Application for Works Approval

Works Approval Number	W6534/2021/1
Applicant	Shire of Coolgardie
File number	DER2021/000058
Premises	Coolgardie Waste Facility Coolgardie Tip Road COOLGARDIE WA 6492 Legal description - Crown Reserve 3497 Lot 501 on Deposited Plan 255090 As defined by the coordinates in Schedule 1 of the works approval
Date of report	02/09/2021
Decision	Works approval granted

Figure 3: Distance to sensitive receptors

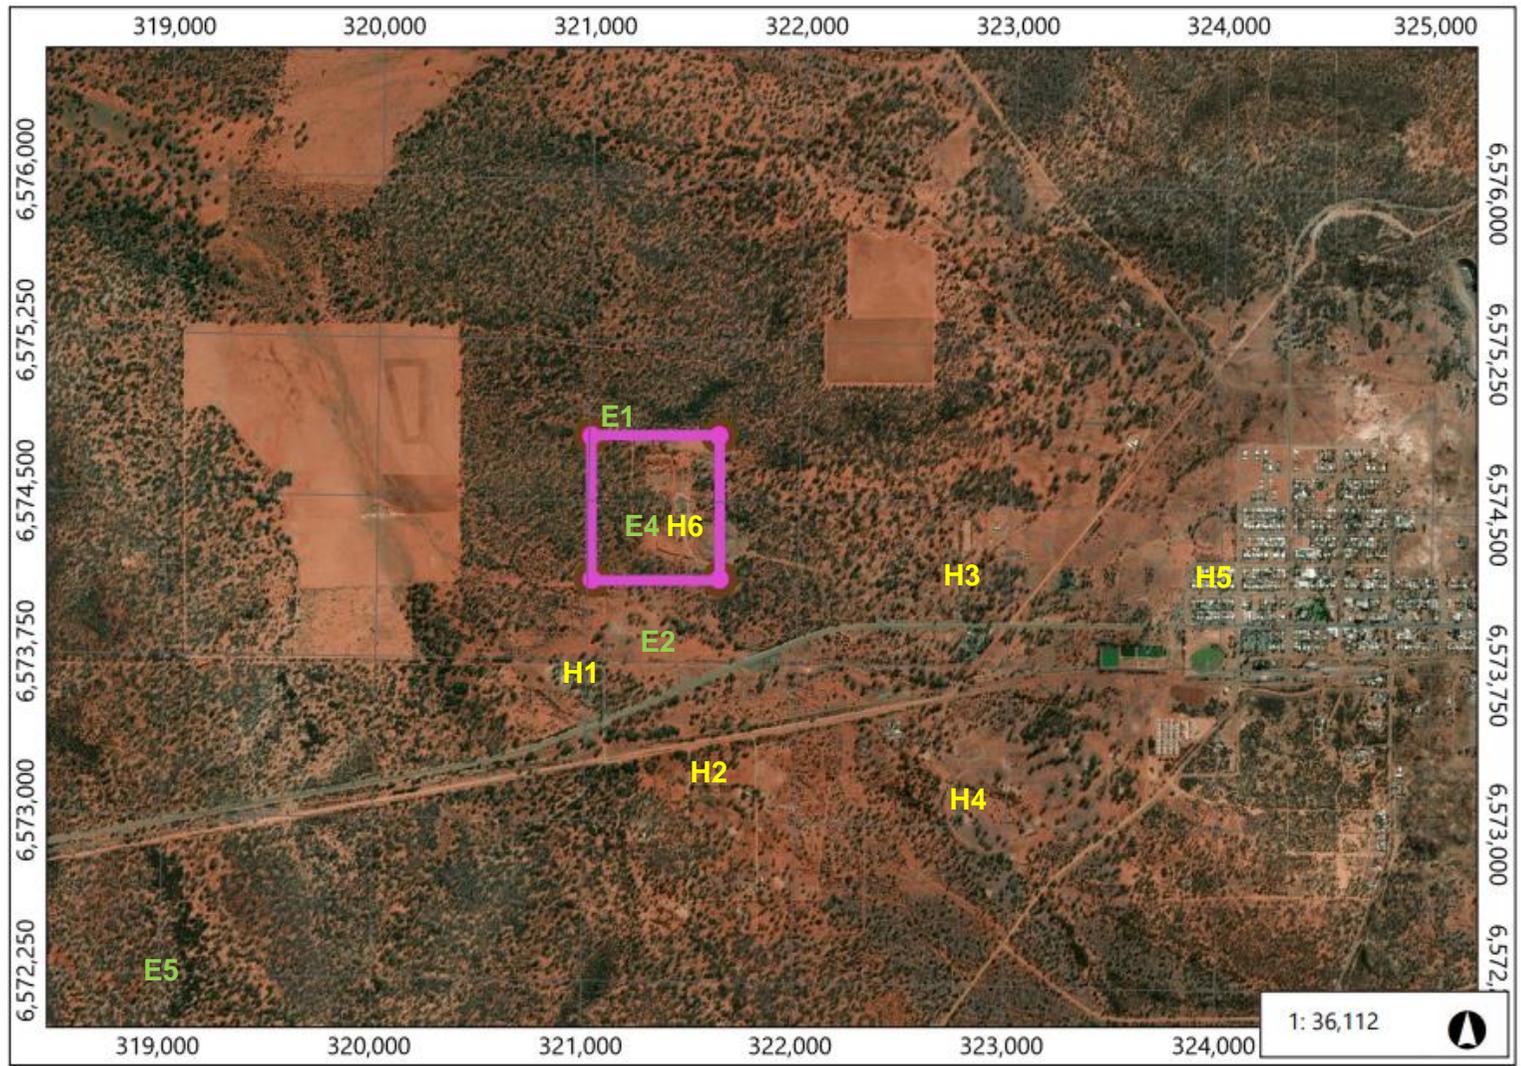
Table 3: Groundwater monitoring requirements	<i>We request that the monitoring location specified in Column 1 of the table is referenced to Schedule 1, Figure 3.</i>	Noted and inserted.

Table 9: Monitoring of groundwater quality	<i>We request that the monitoring location specified in Column 1 of the table is referenced to Schedule 1, Figure 3.</i>				Noted and reference inserted.
Table 10: Monitoring of surface water and leachate quality.	<i>We request that the monitoring location specified in Column 1 of the table is referenced to Schedule 1, Figure 3.</i>				Noted and reference inserted.
Table 11: Definitions Qualified CQA Engineer/Consultant	<p><i>As described in the definition, the role of CQA Engineer/Consultant would be limited to holders of a Bachelor of Engineering degree recognised by the Institute of Engineers.</i></p> <p><i>We request that this qualification requirement be extended to non-degree holders, such as qualified and experienced technicians or scientists with suitable certification such as Geotechnical Inspection and Testing Authority (GITA), Third Party Construction Quality Assurance Consultant (TPCC) or Geosynthetic Certification Institute – Inspectors Certification Program (GCI-ICP).</i></p> <p><i>This will allow for greater flexibility in selecting a suitable CQA Engineer/Consultant for both the earthworks (subgrade, compacted clay liner) and geosynthetics components (GCL, geomembrane, geotextile) of the lining systems whilst maintaining, and potentially exceeding, the level of qualification and experience required by the current definition.</i></p>				DWER has retained the requirement for a suitably Qualified Engineer to certify works specified in Condition 2 and Table 2. The following definition has been specified: means a person who: <ul style="list-style-type: none"> a) holds a Bachelor of Engineering recognised by the Institute of Engineers; and b) has a minimum of five years
